SERVICE BULLETIN

Machines/Models: X-Series
Work Platforms

SERVICE BULLETIN: 94.7, THE INSTALLATION OF THIS KIT IS MANDATORY!

PURPOSE: Notification of requirement to change rear axles.

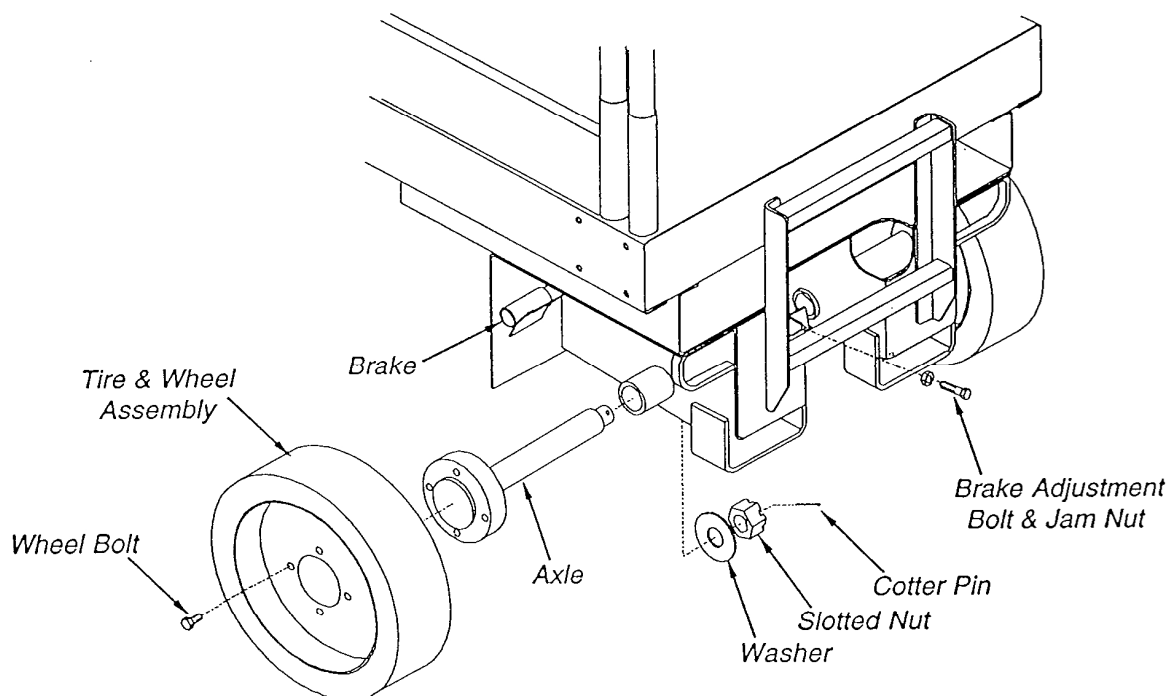
OPERATION REQUIRED: Replacement of both rear axles.

PARTS REQUIRED: 1- 30711-001, Rear Axle Kit.

1. Block front wheels to keep the machine from rolling. Using a jack of adequate capacity, raise the rear of the machine and block with jack stands.

2. Release parking brakes by loosening jam nut and brake adjustment bolt until brakes clear the tires and the wheels turn freely.
3. Remove both rear tire and wheel assemblies.

4. Remove cotter pin, slotted nut and washer from axle.
5. Slide old axles out of the chassis and discard.
6. Install new axles in chassis.
7. Install washers and slotted nuts. Tighten nuts hand tight only.

8. Install new cotter pins, **DO NOT** back off nut to install cotter pin.
9. Install both rear tire and wheel assemblies. Torque wheel bolts to 75 Ft./Lbs. (102 Nm).

10. Tighten the brake adjustment bolt until the brakes fully engage the tires, secure bolt with jam nut.
12. Operate machine and check for proper operation and brake function.
